Service Bulletin TTC-SB-DHC3-03-REV-A

Title: Parallel/Series Start System Modification

Effectivity: All DHC-3 Otter aircraft modified with Texas Turbine Conversions, Inc. STC SA09866SC or Canadian STC SA02-15, turbine engine conversion modified prior to October 1, 2005.

Figure 1

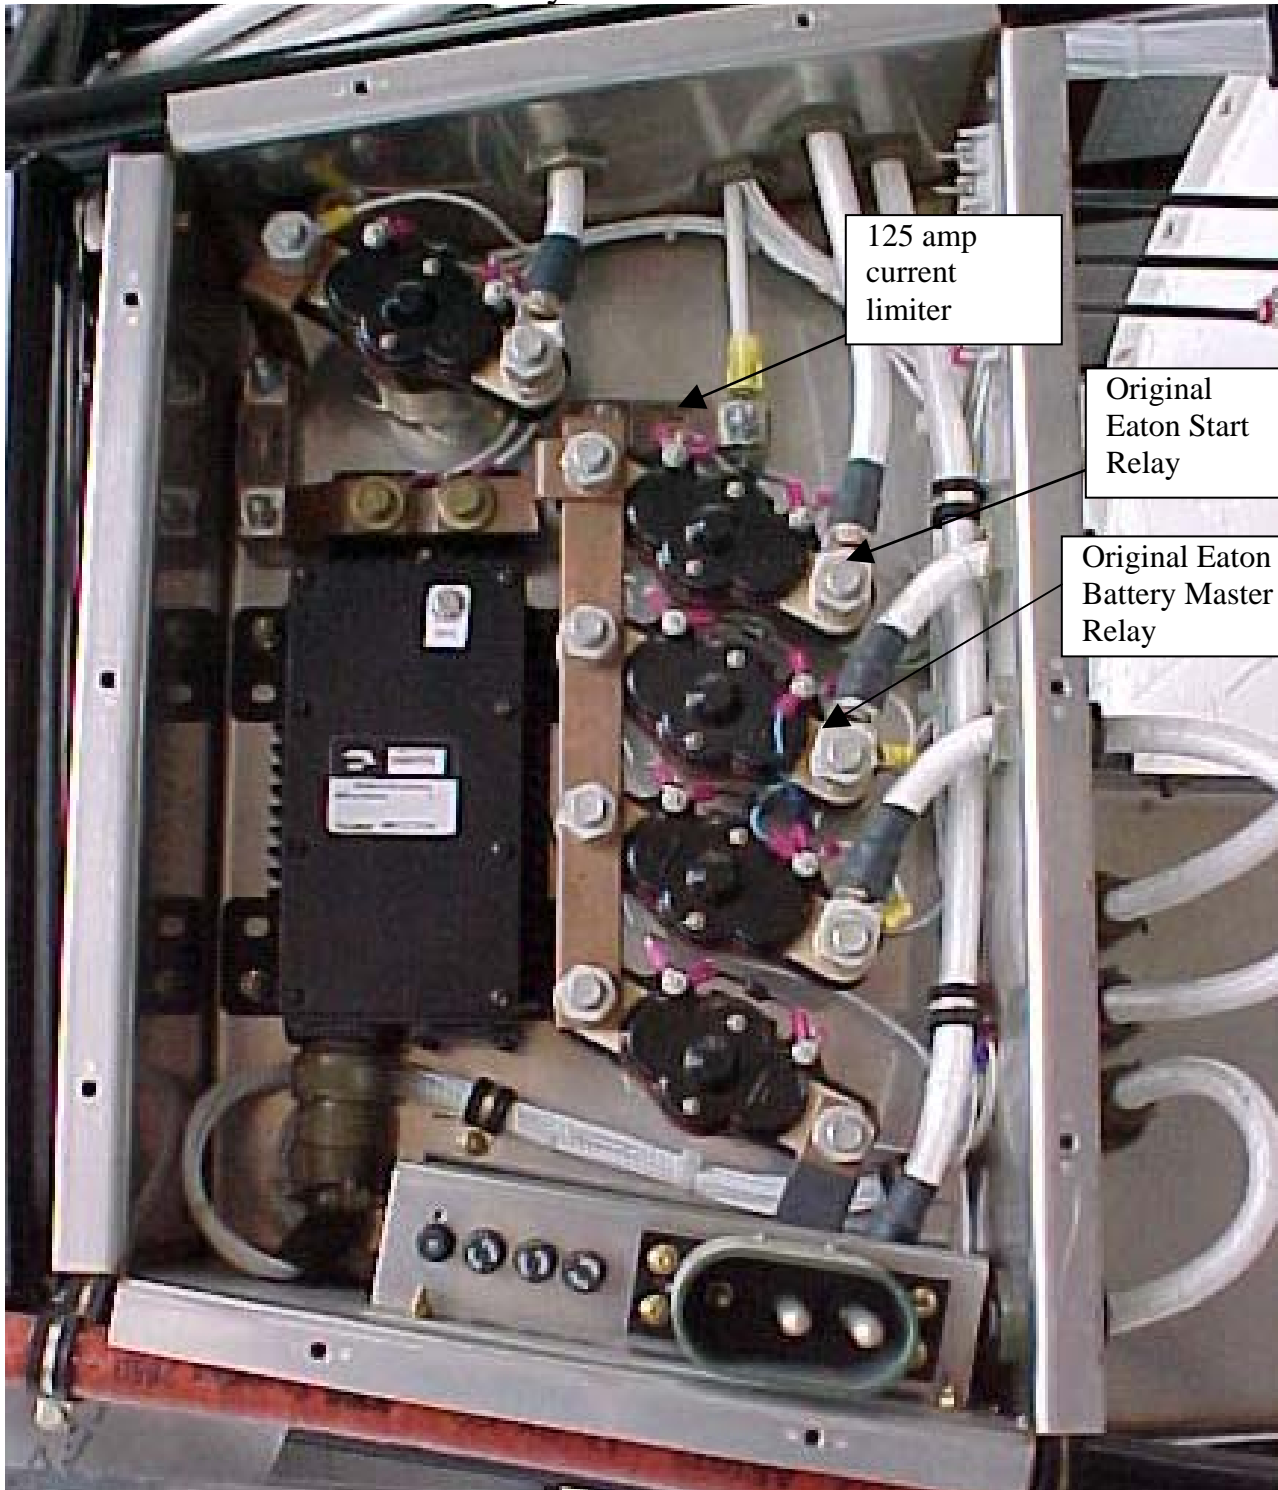
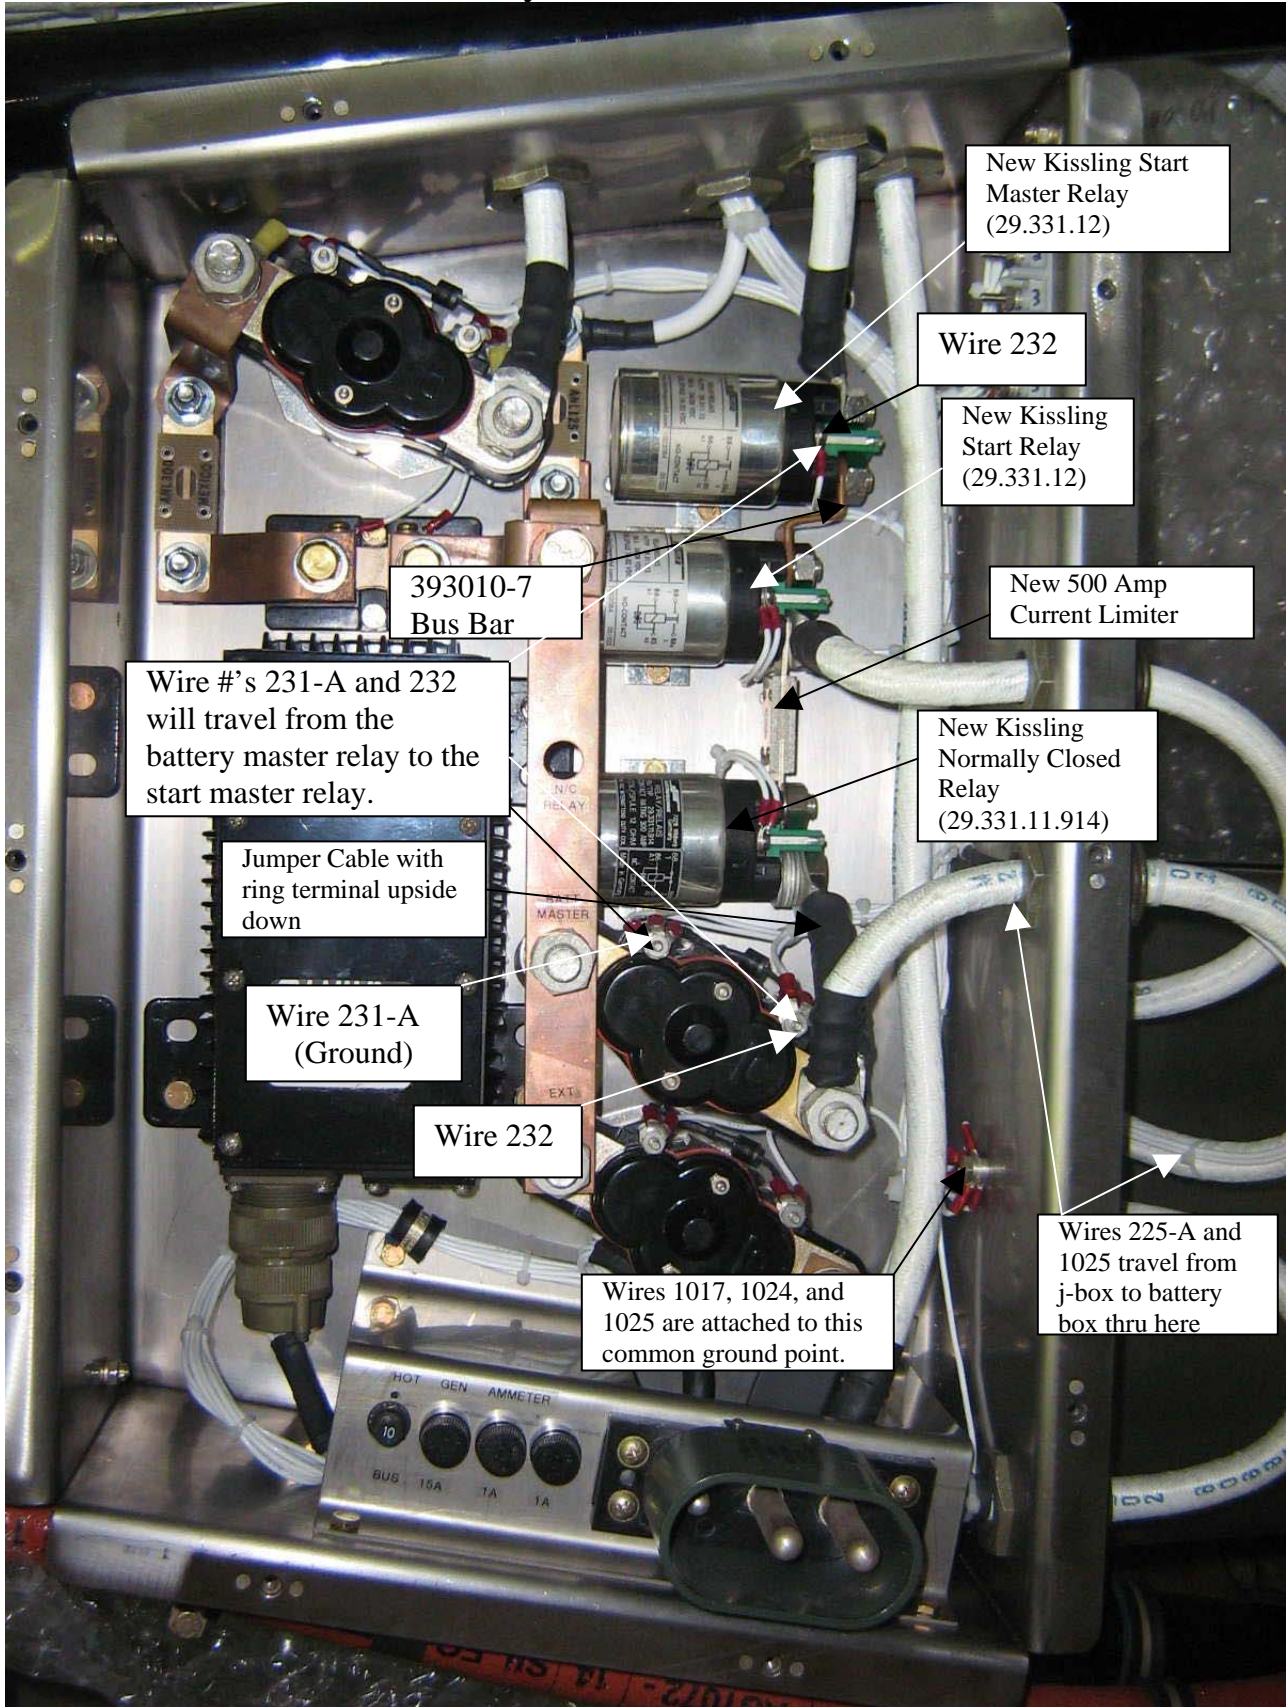
4. Remove electrical junction box (j-box) cover.
5. Remove the Eaton start relay and upper Eaton battery master relay (see figure 1). Remove the 125 amp current limiter, and the mount screws. Rotate the current limiter mount vertical and mark and re-drill the holes with a #10 drill and de-burr.

8. Hold the current limiter/relay assembly up to the junction box in the mounting location depicted in the photo (approx. 1/4" from previous horizontal 125 amp current limiter mounting base position) and mark the four holes to mount the relays in the j-box (see figure 2). Drill the four holes in the junction box using a #10 drill. De-burr the holes.

10. Install the relay assembly in the electrical junction box using 4 bolts (AN3-4A), 4 washers (AN960-10), and 4 steel lock nuts (AN363-1032). Then using the 393010-7 Bus bar for alignment, Match drill the start master relay(29.311.12) to J-box , (as depicted in fig. 2) and de-bur.

16. Attach wires 1017, 1024, and 1025 to the common ground point using the #10 ring terminals provided.
17. Cut the starter cable to the appropriate length (remove ½” ring terminal) to attach to the (1 or 88) terminal of the new top start relay. Crimp a 3/8” 70-10 ring terminal on the cable and install it on the relay. (see figure 2 for ring terminal clocking)

Figure 3

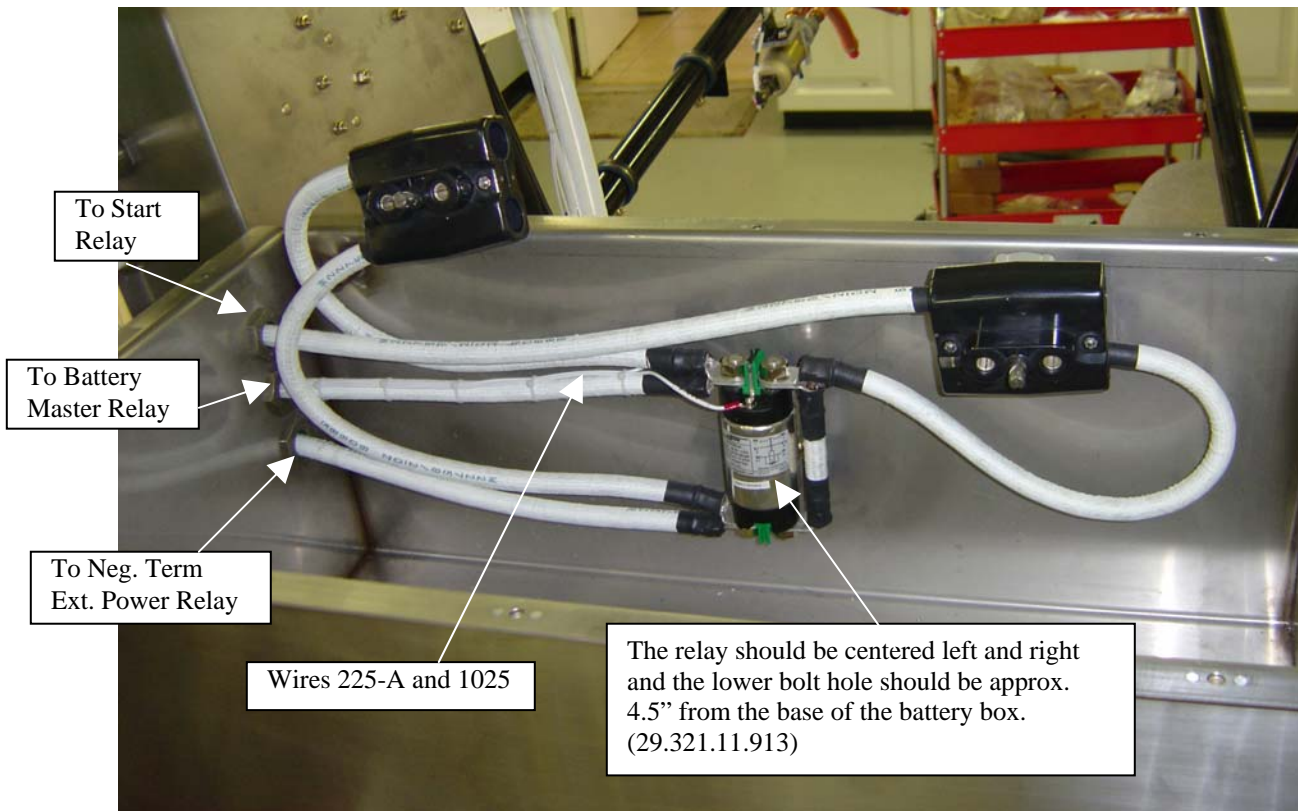
12. Install the parallel/series transfer relay (29.321.11.913) in the battery box as depicted in figure 3 using two (AN3-4A) bolts, two (AN960-10) washers, and two (AN363-1032) nuts in diagonally opposing holes.

14. Attach existing wire 225 and a new wire 225-A (MS22759/8-18-9) to the terminal A2 of the normally closed relay. Route wire 225-A from normally closed relay terminal A2 out the strain relief clamp for the battery relay in the j-box and go in the middle strain relief of the battery box to the A2 terminal on the parallel/series transfer relay using a #8 ring terminal (see figure 3).

15. Route the new ground wire 1025 (MS22759/8-18-9) from the common ground point in the j-box to the battery box following the same path as wire 225-A, except attach wire 1025 to the A1 terminal on the parallel/series transfer relay using a #8 ring terminal. Use tie wraps to secure wires 1025 and 225-A to the middle heavy gauge wire of the battery box (see figure 3).

21. Cut the heavy gauge wire coming thru the middle strain relief (from the battery master relay) of the battery box to the proper length to allow installation of the wire on the top (1 or 88) terminal of the parallel/series transfer relay (see figure 3). Crimp a 3/8” 70-10 ring terminal at the new cut length.

22. Loosen the bottom heavy gauge strain relief on the battery box for the negative cable and push the cable further into the box to attach to the bottom post (4 or 87a) of the parallel/series transfer relay as depicted in figure 3. The existing 3/8" 70-10 ring terminal might have to be cut off and a new one installed to allow for proper clocking of the ring terminal. If the cable is not long enough, a new cable must be fabricated from the external power plug to the parallel/series transfer relay using the cable and 3/8" 70-10 ring terminals supplied in the kit.

24. Fabricate the heavy gauge jumper wire from the top terminal (2 or 88a) of the parallel-series transfer relay to the bottom terminal (3 or 87) using the MS22759/2-02-9 wire and the 3/8" 70-10 ring terminals that were supplied with the kit. Again, pay careful attention to ring terminal clocking. (see figure 3)

Figure 4

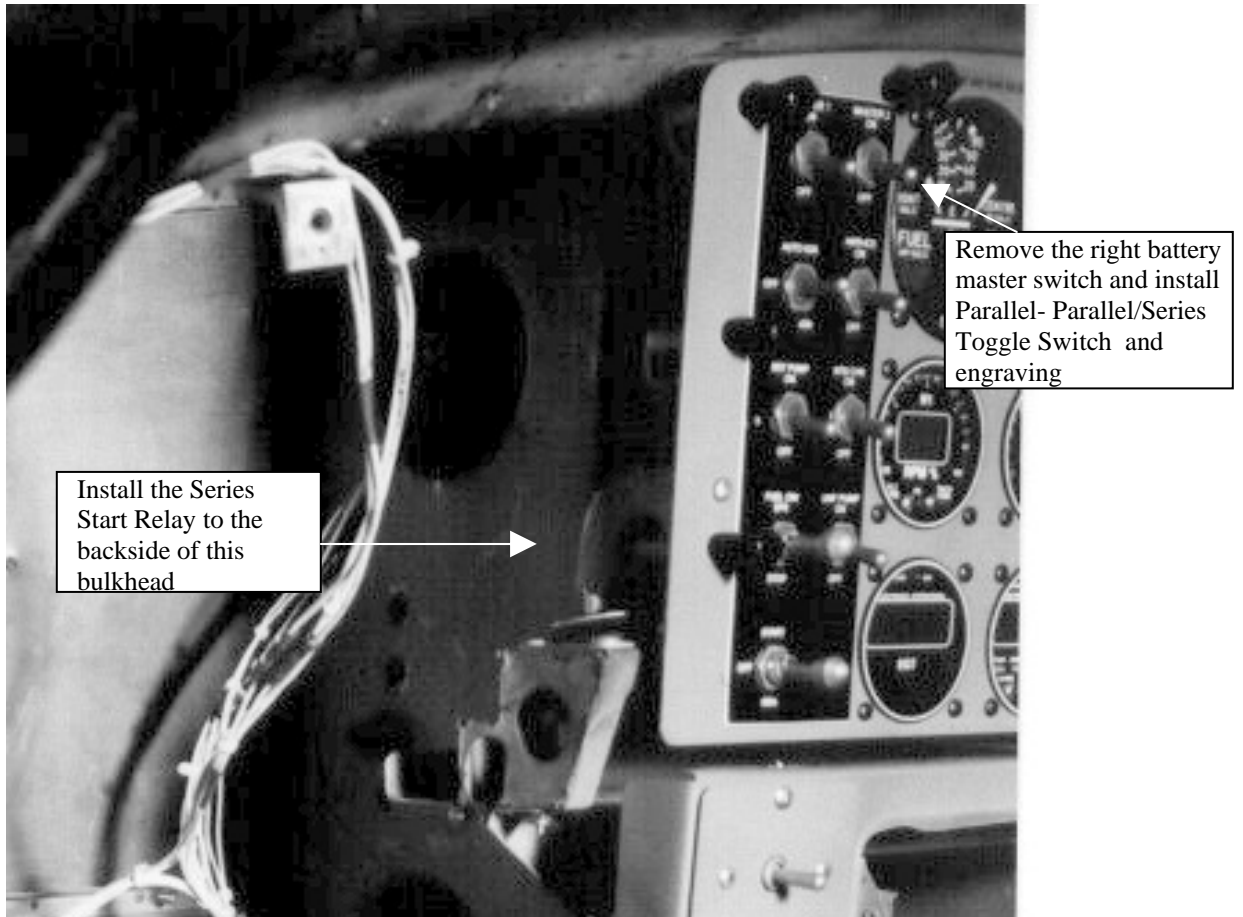
28. In the cockpit, remove the engine instrument panel to allow installation of the series start relay.
29. Install the series start relay (PN. KUP-5D55-24) on the left bulkhead as depicted in figure 4 using two MS27039-0808 screws, two AN960-08 washers, and two MS21083N08 nylon nuts.

Figure 5

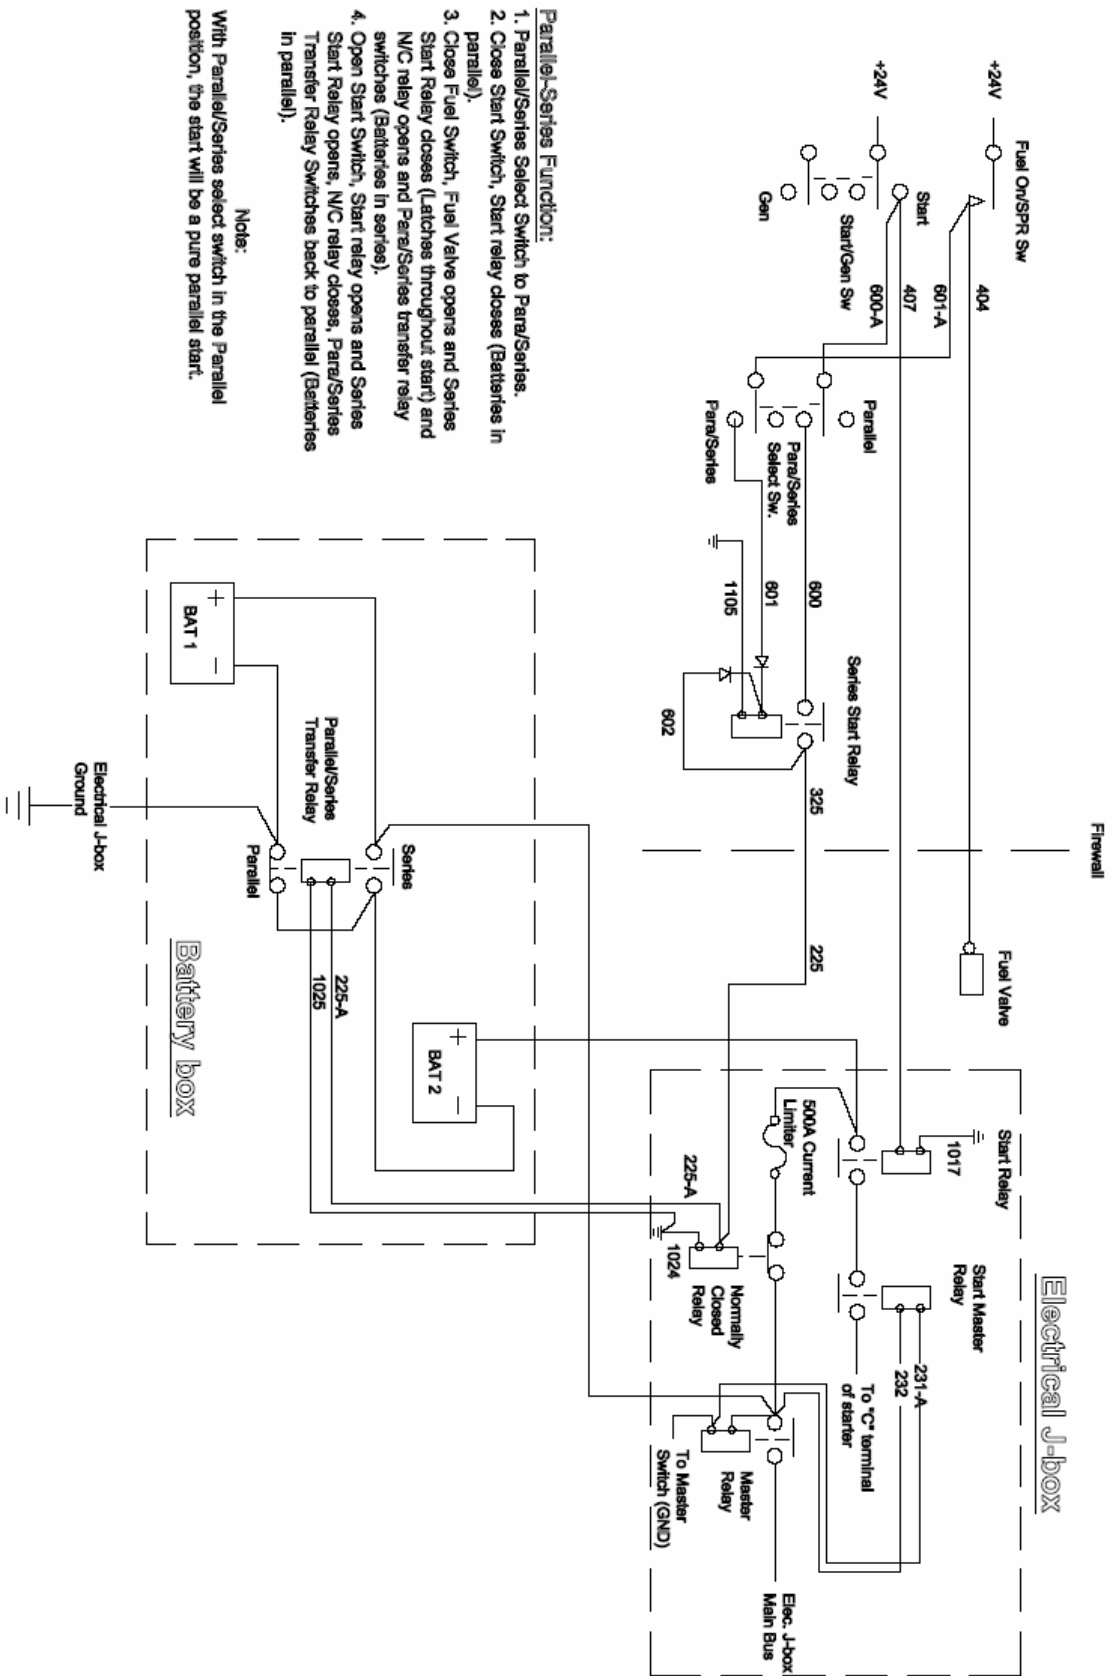
30. Remove wires 325 and 1105 from the battery master switch and cut the ring terminals off to facilitate removal from the engine instrument panel harness. Route the wires over to the Series Start Relay that was just installed. Connect wires 325 and 1105 to the appropriate marked wires of the series relay using the spade terminals provided in the kit (see figure 5).

31. Fabricate and install wire 600-A (MS22759/16-18-9) on the START/GEN switch on the same post as wire 407 using a #8 ring terminal. Route the wire along the existing harness to the Para/Series Toggle Switch and attach it to the appropriately marked terminal of the switch. (see fig. 5)

32. Fabricate and install wire 601-A (MS22759/16-18-9) on the FUEL ON/SPR switch on the same post as wire 404 using a #8 ring terminal. Route the wire along the existing harness to the Para/Series Toggle Switch and attach it to the appropriately marked terminal of the switch. (see fig. 5)

33. Fabricate wires 600 and 601 using wire (MS22759/16-18-9) and using #8 ring terminals, run them between the Para/Series Switch and the Series Start Relay and attach to appropriately marked leads or terminals. (see figure 5)
